Job: TCPJ10-101 Portland Jetport Expansion

Submittal Title: FIRE ALARM SHOP DRAWINGS / CALCULATIONS

Here is our reply to the comments relating to the revised FA drawings that John Hale reviewed with you last week.

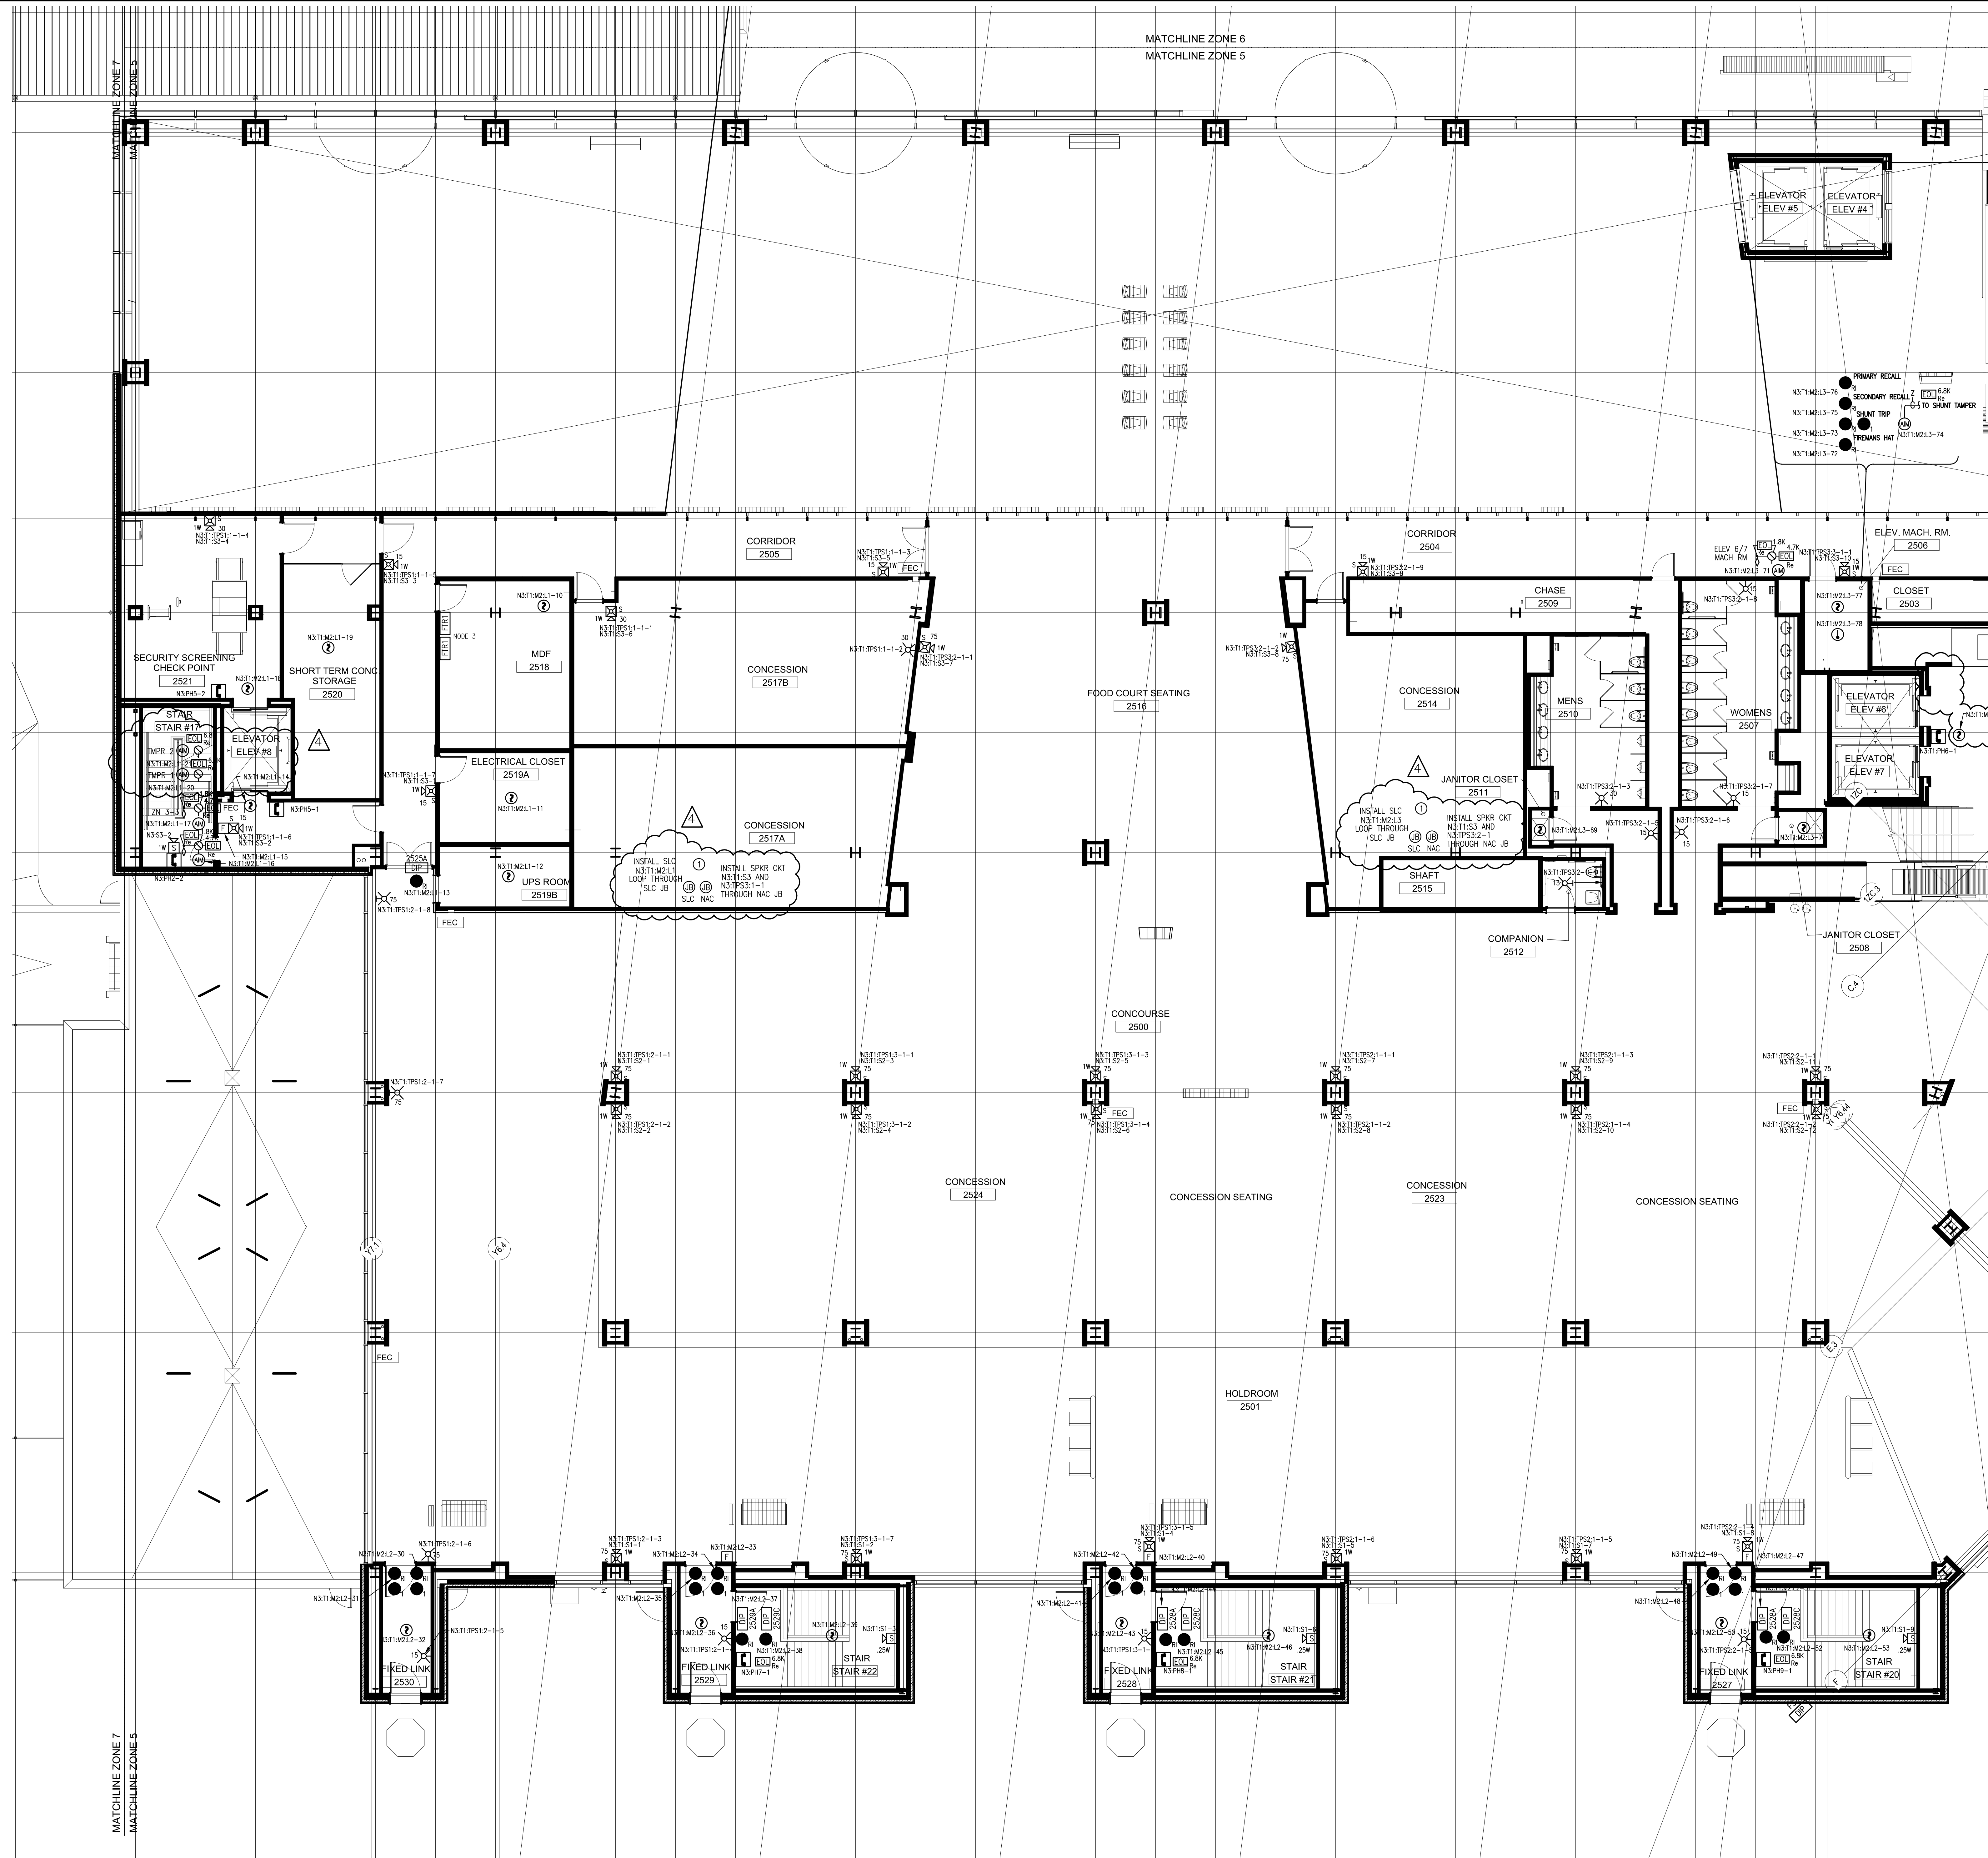
FA-110:

- Changes/corrections/modifications have been made.
- Per contract: Junction boxes not provided by SimplexGrinnell.

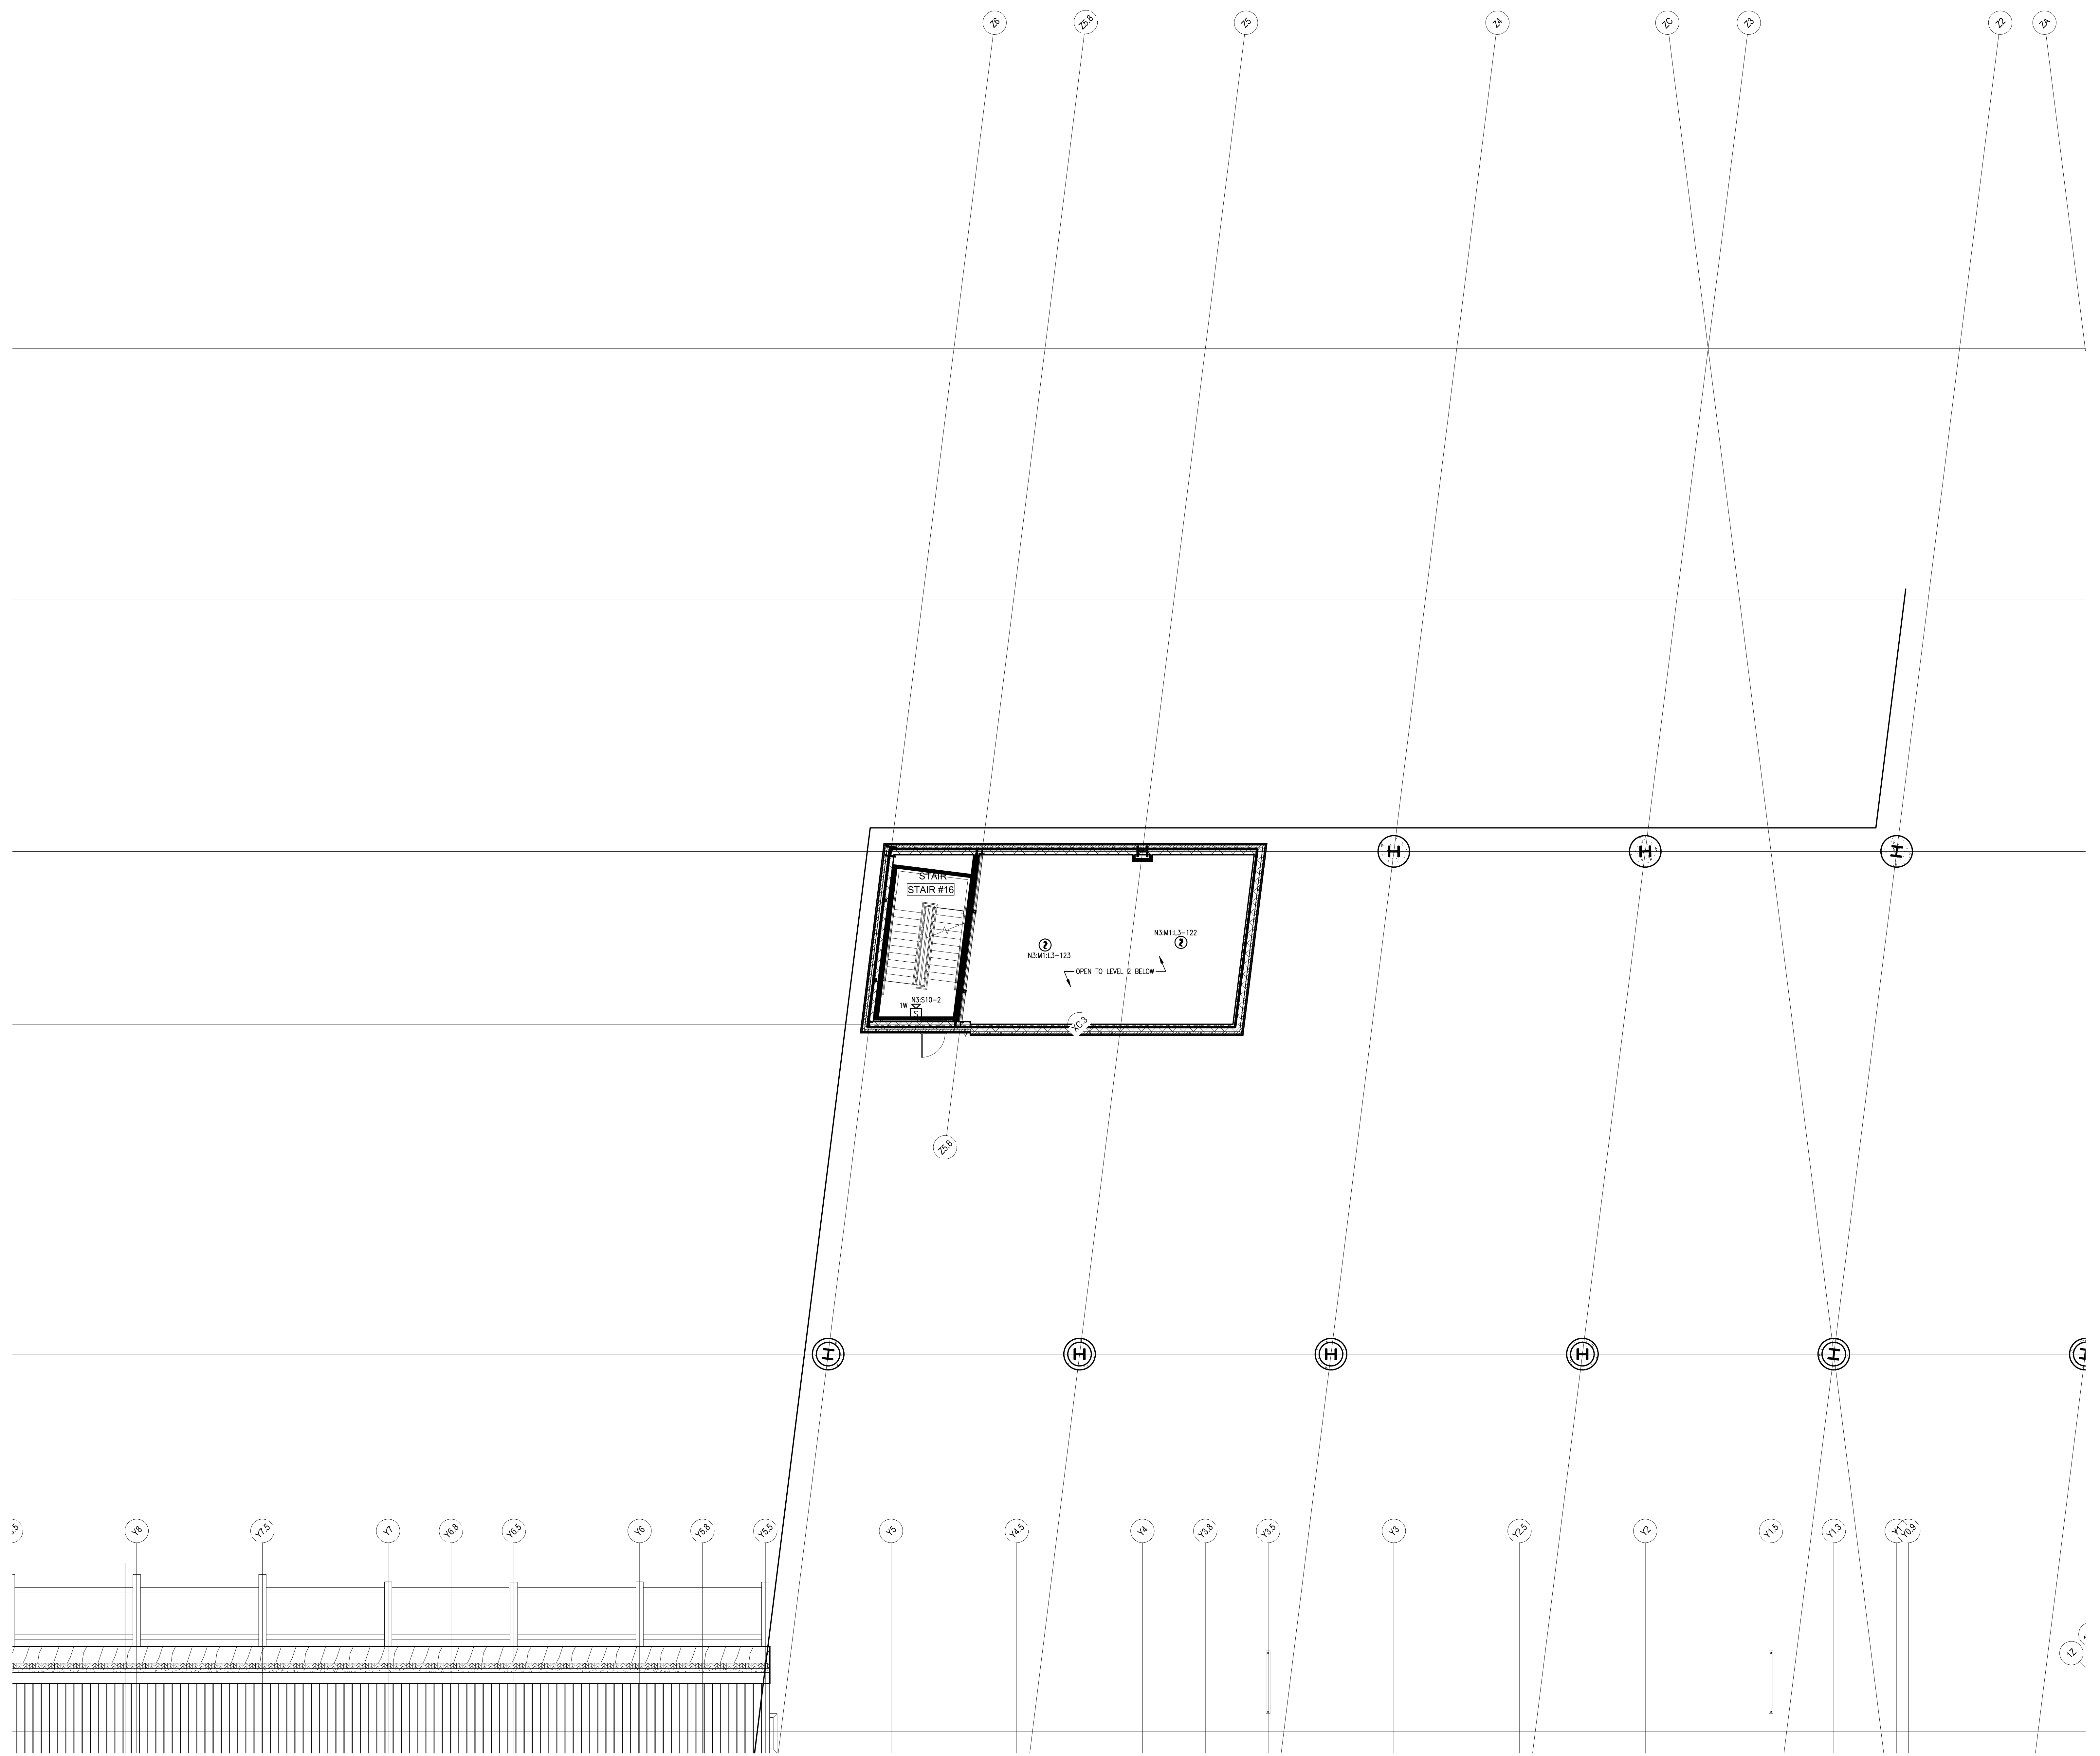
FA-111:

- Per contract: Junction boxes not provided by SimplexGrinnell.
- Changes/corrections/modifications have been made per updated background DWGs.

SHEET TITLE: FIRE ALARM SYSTEM LEVEL 4 - ZONE 5
 SHEET NUMBER: FA-113

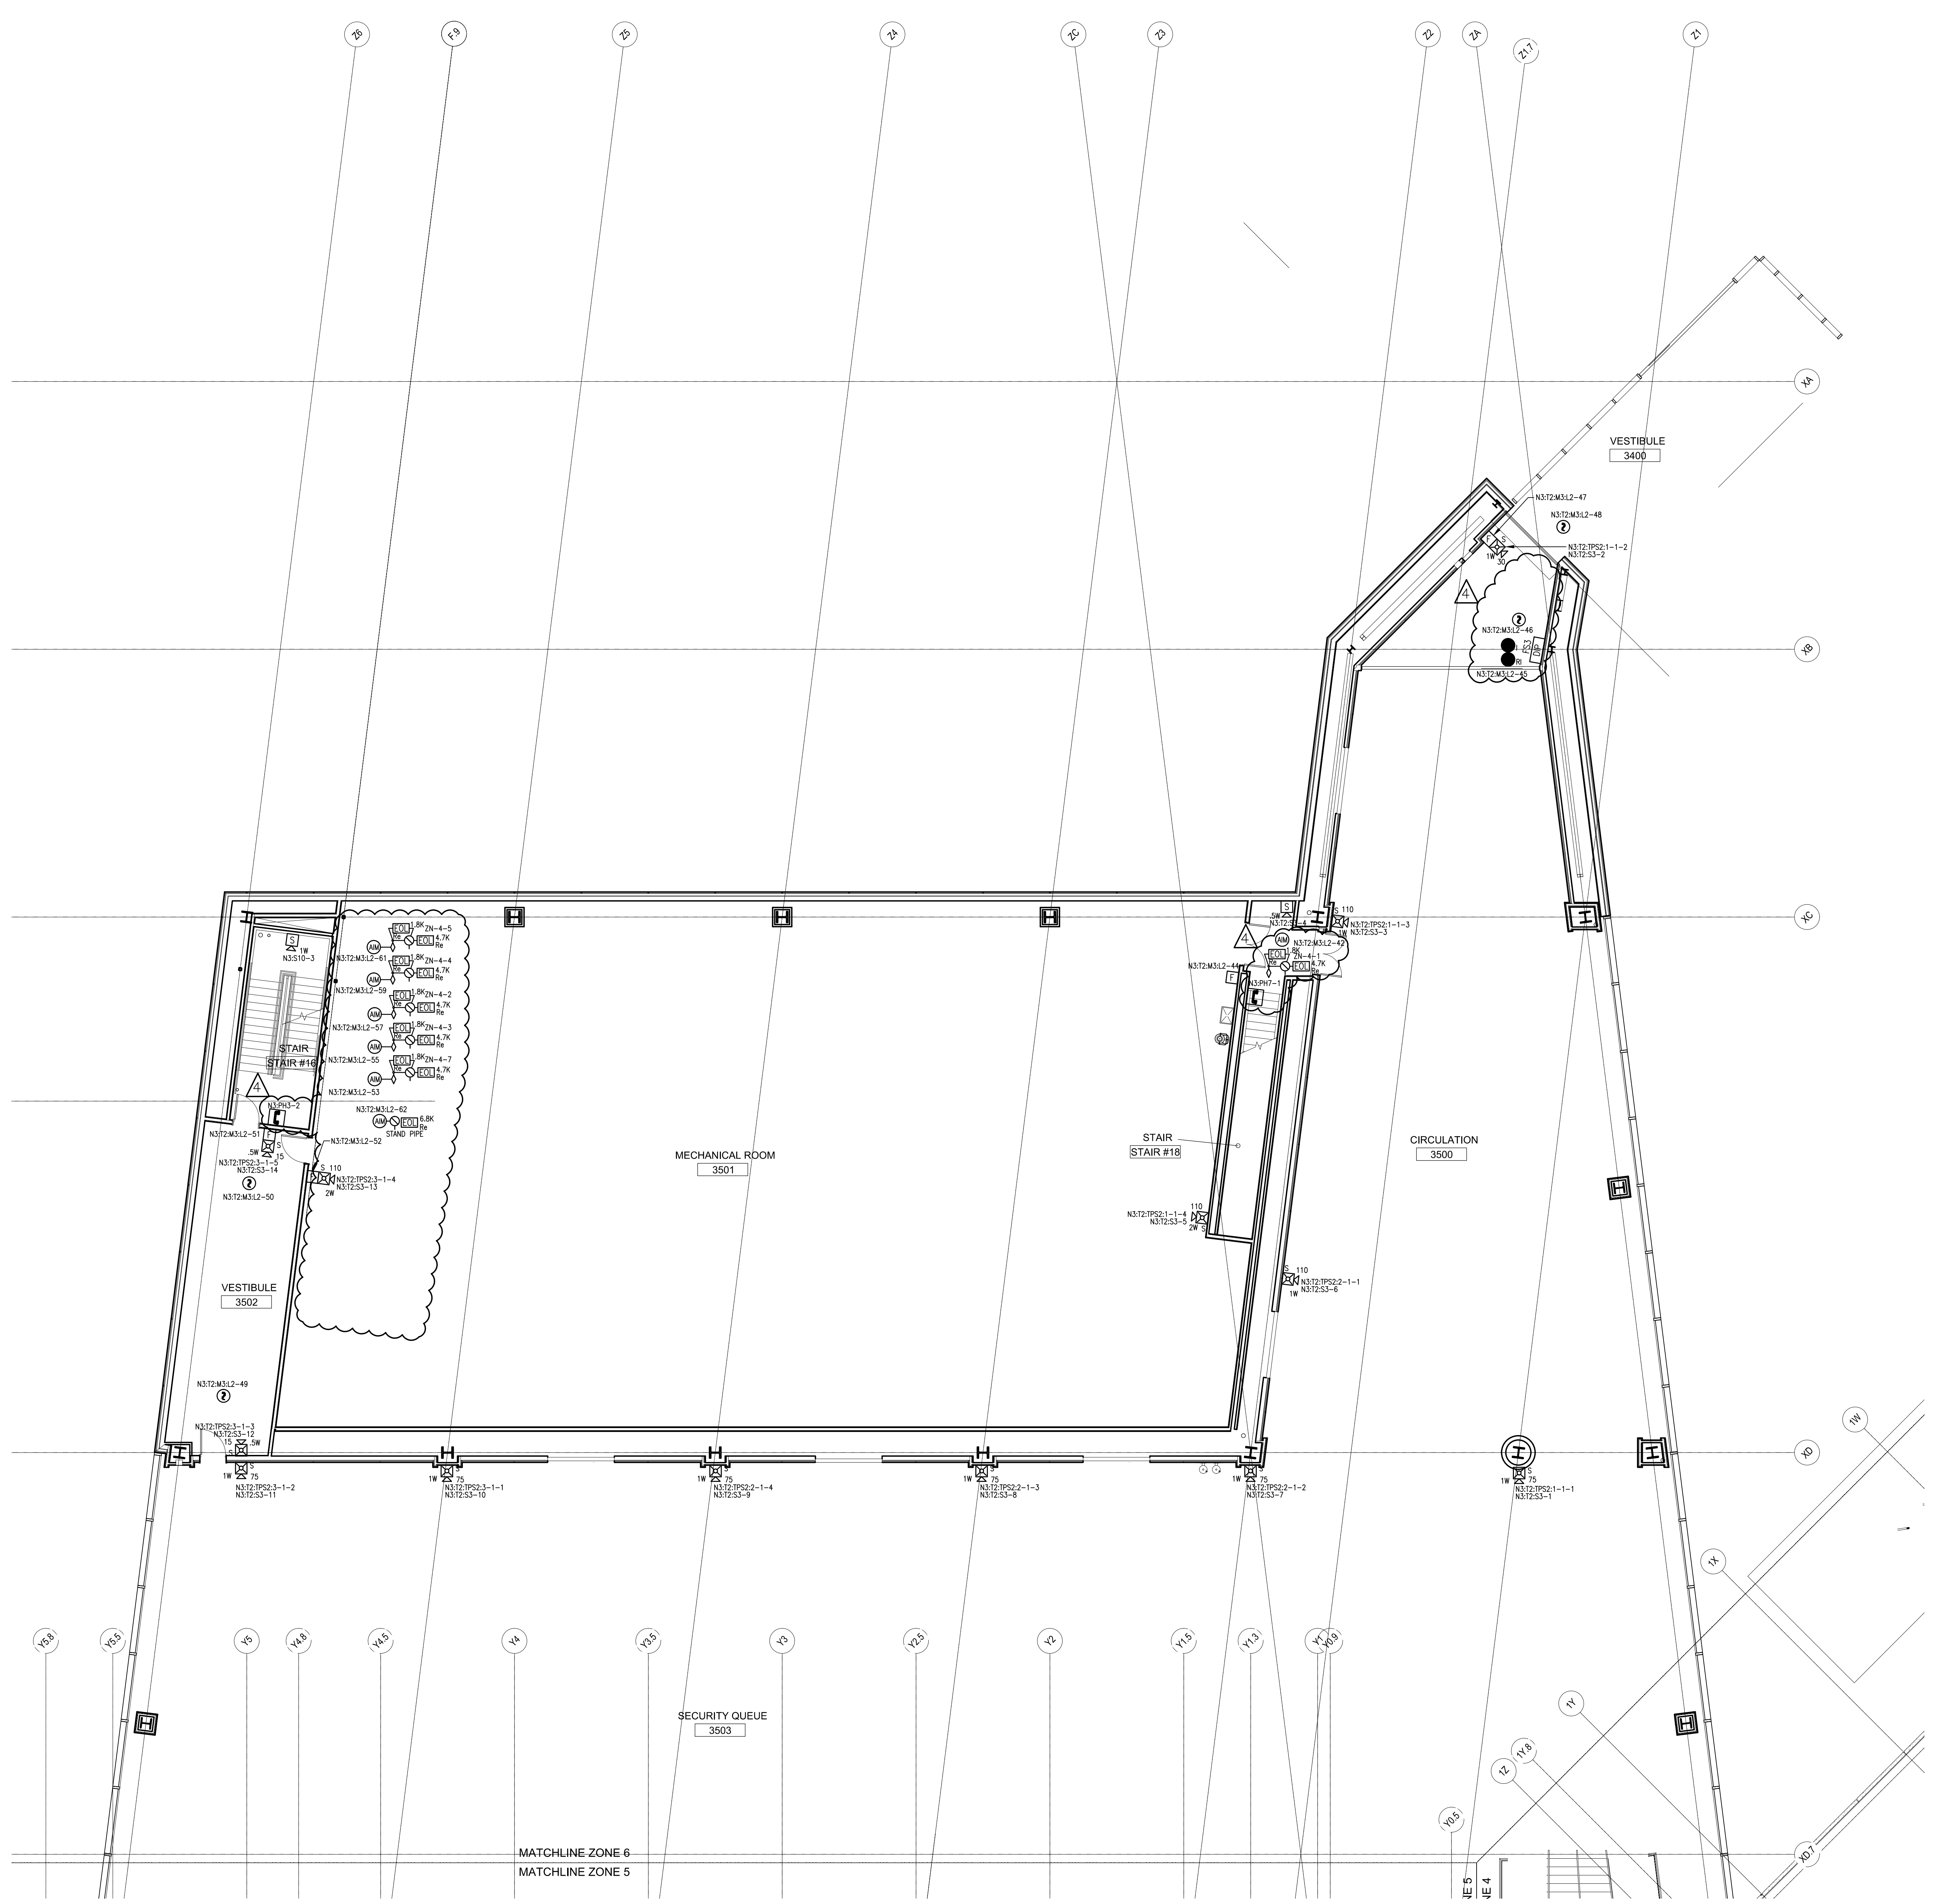
FA-113:

- Changes/corrections/modifications have been made.
